Dock Branch Neighbourhood Masterplan Consultation

Report: 11 December 2023

Dock Branch Neighbourhood Masterplan - Community Panel Response

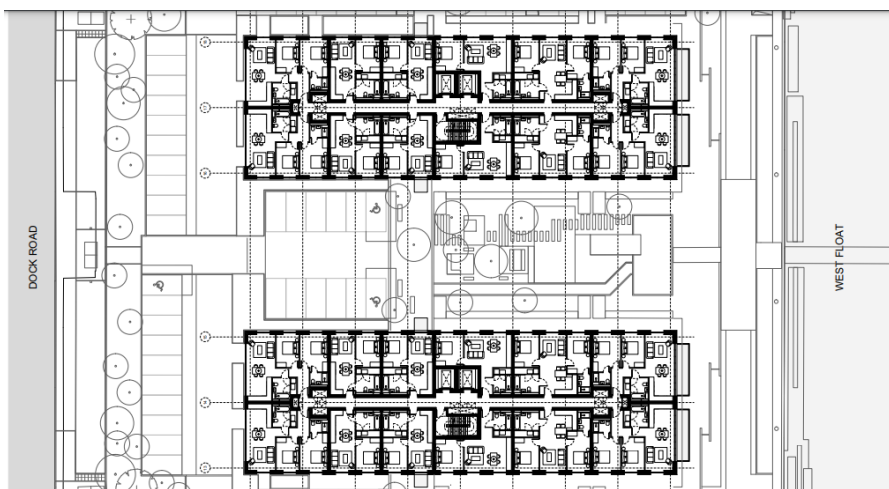
2.2.1 Paragraph 9 line 7; **Social inclusion and participation**

“stewarded” should be listed and undertaken ahead of “designed” so that stewardship learning can inform design briefing that is specific to Birkenhead.

Paragraph 11 line 8; **Mixed workspaces** – but see 2.1.5 Paragraph 6 “Concealed behind warehouse and workshops doors” above – **which is it supposed to be and how will it work?**

Paragraph 14 line 4 & 5; **Circularity and local production** - How does the Masterplan integrate? Is there social integration at present and can this be encouraged, years ahead of physical change? If not, why not? If not now, why will social integration happen as a result of material, spatial and physical interventions that are masterplan-oriented, such as building and street design?

Paragraph 15 line 1; **Leisure and recreation** Are these civic or commercial suggestions for Birkenhead? Is this part of what is described as a “hard measures” Masterplan or is this just the equivalent of a magazine article?
